To: Anthony J. Quigley, District 1 Attn: Christopher J. Holt
From: D. Carl Puzey By: Timothy A. Armbrecht
Subject: PRELIMINARY BRIDGE DESIGN APPROVAL
Date: October 24, 2018

STP – Bridge Funding
City of Highland Park
Section 15-00125-00-PV

SN 049-6585

FAU 1265 (Clavey Road) & Multi-Use Path over Skokie River

**GENERAL PLAN & ELEVATION
CLAVEY ROAD OVER SKOKIE DITCH
SECTION 15-00125-00-PV
LAKE COUNTY
STATION 129+46.00
STRUCTURE NO. 049-6585**

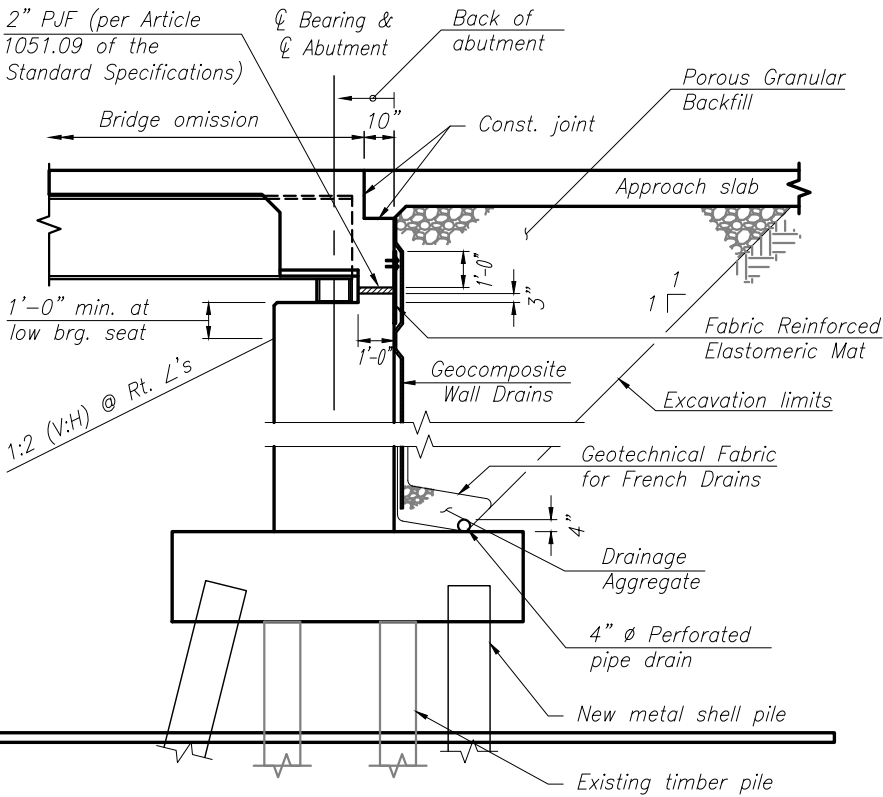
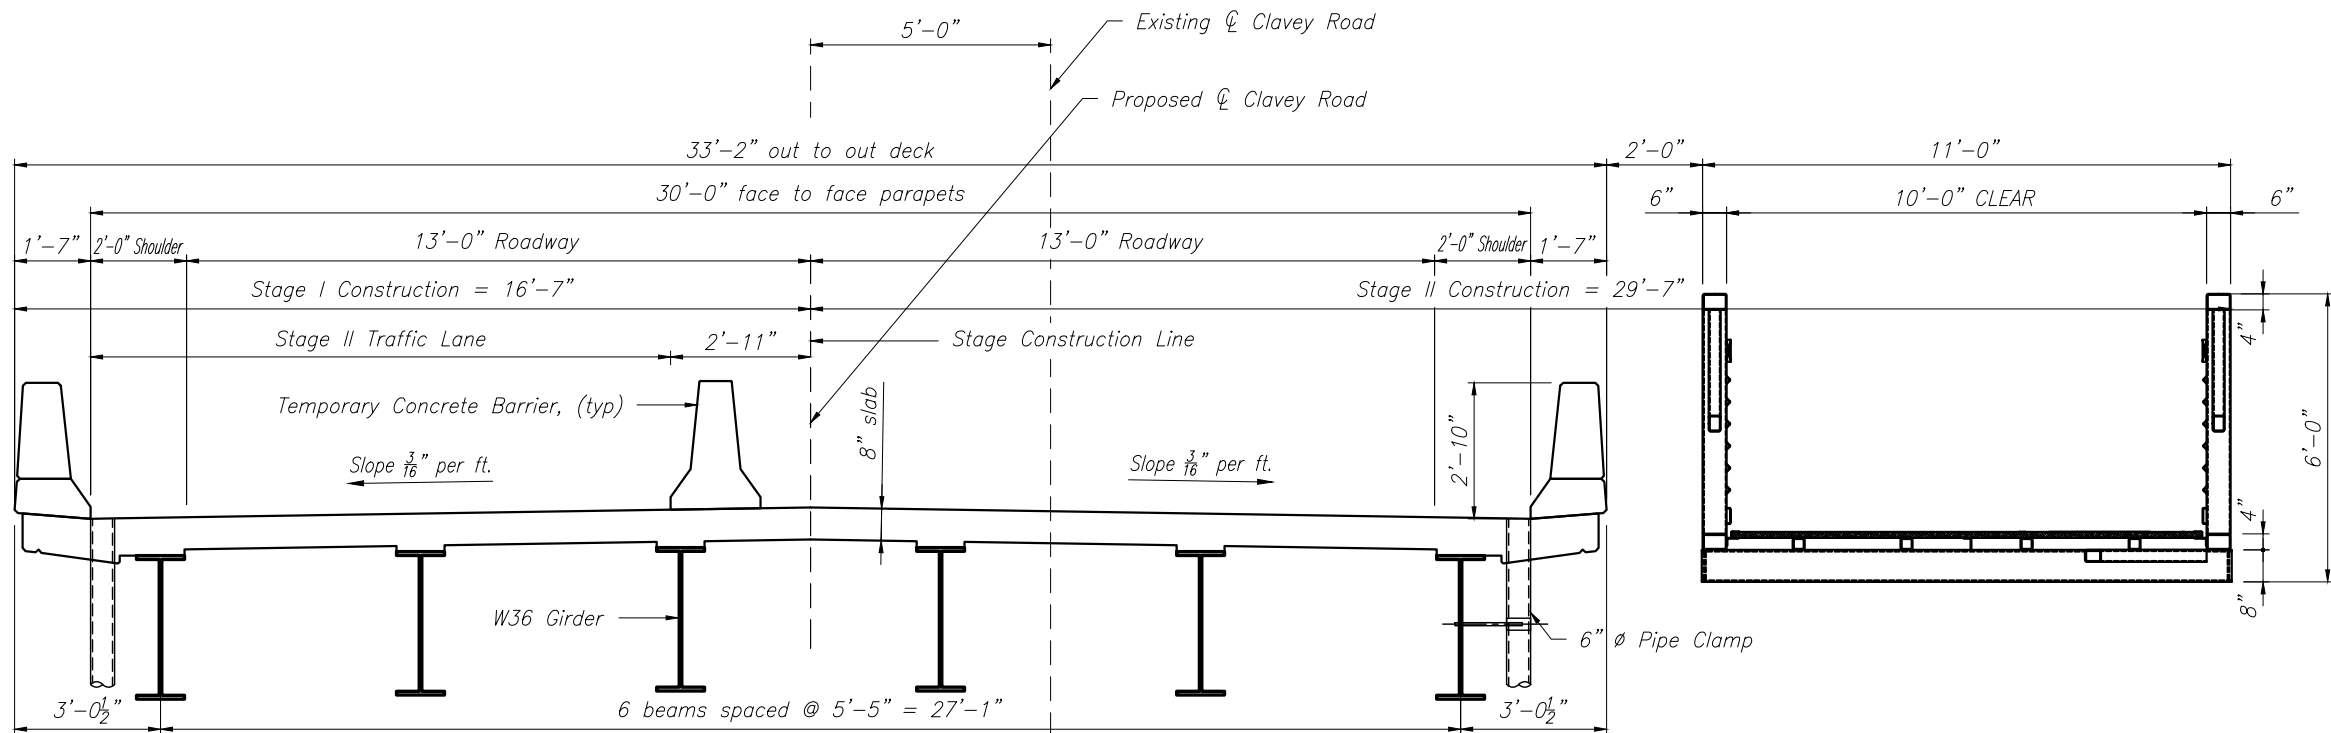
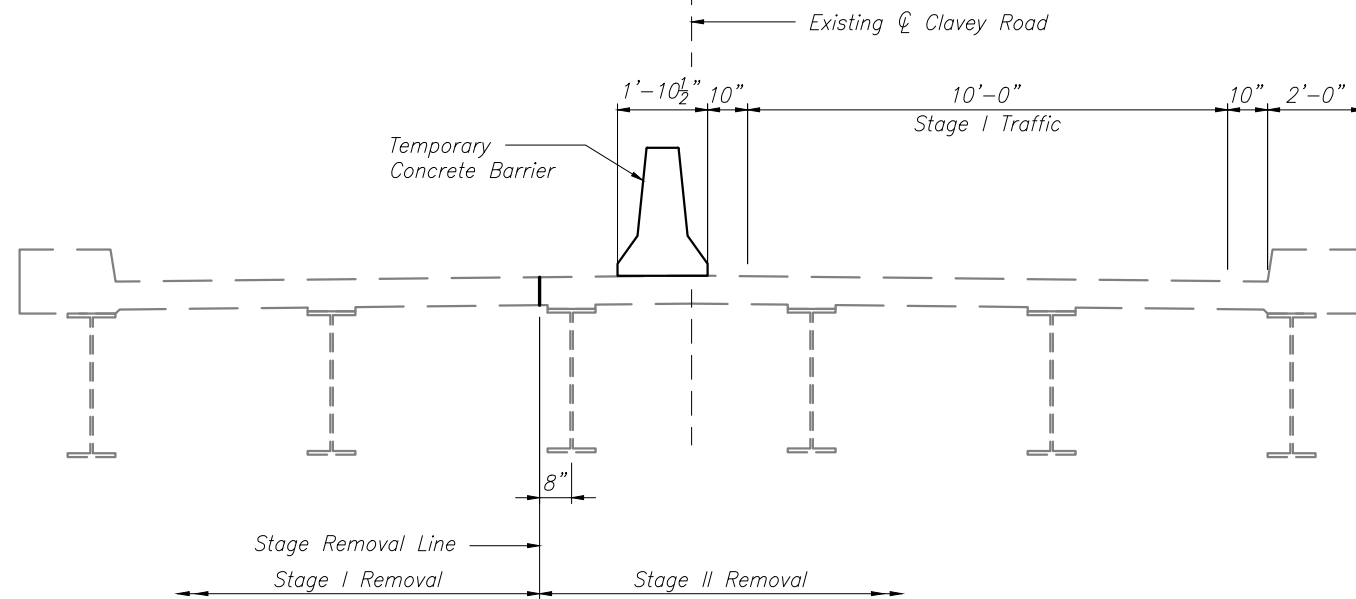
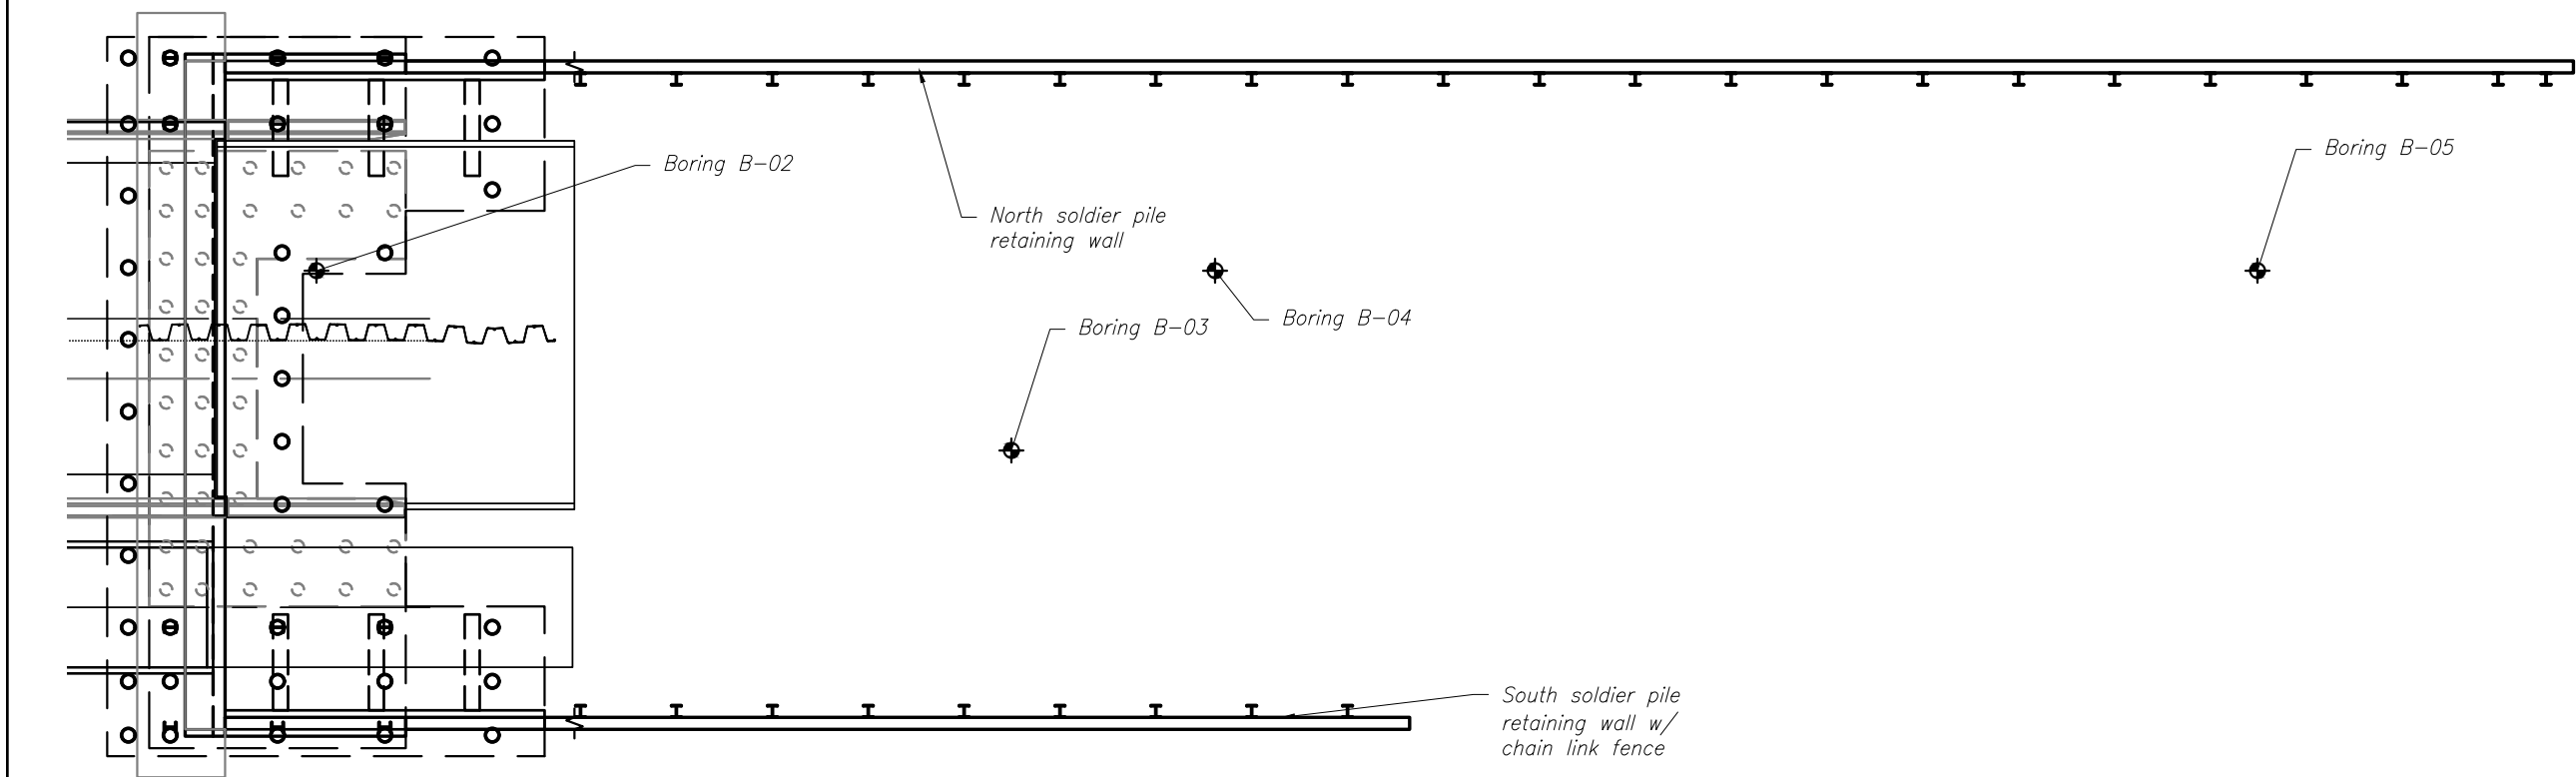
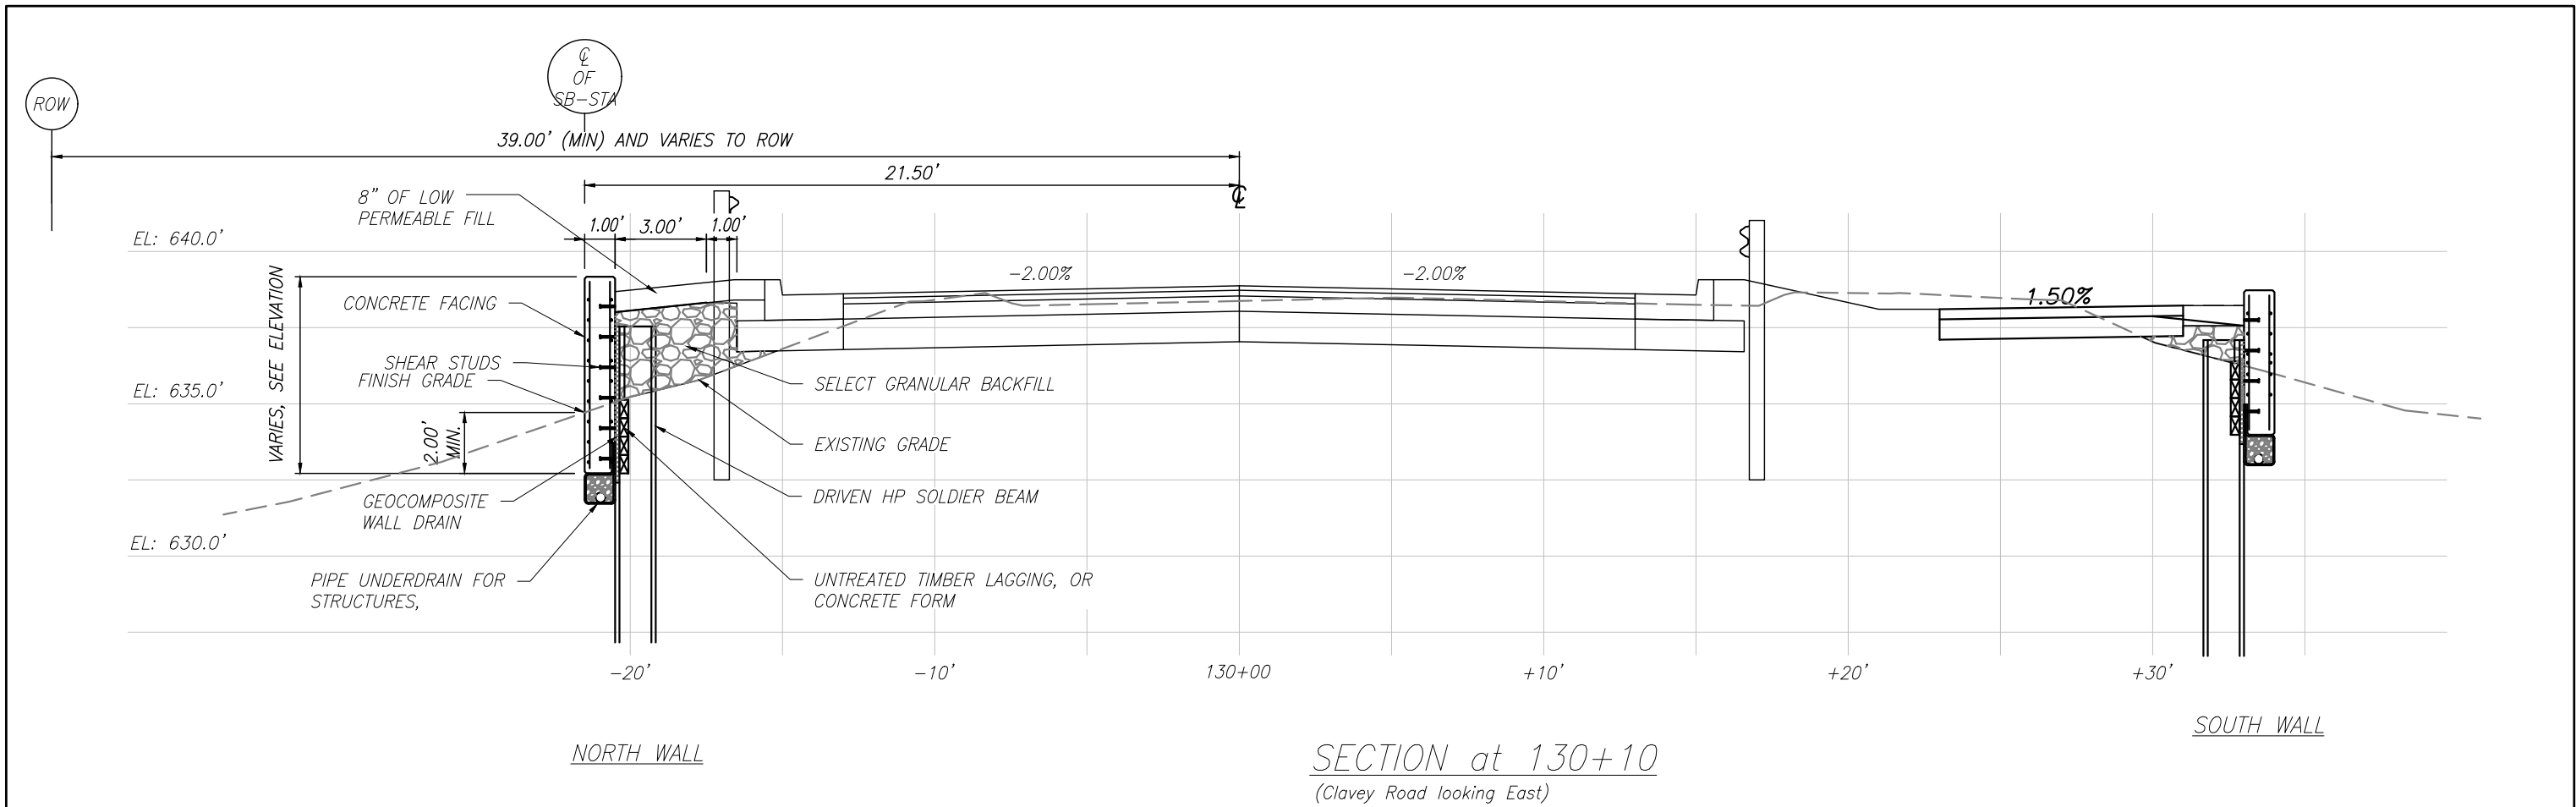
As discussed during our review, it appears it may be advantageous to skew the structures to match the alignment of Skokie River. If changes are determined to be appropriate at a later date, please contact our office for resubmittal requirements.

The locations of the proposed foundations appear to be at or near the existing substructure locations. Care must be taken during construction to locate existing substructure elements to prevent damage or conflicts with the new pile locations. If conflicts arise and modifications are required of the pile locations or design shown on the plans, the Structural Engineer of record should be notified for approval of revisions.
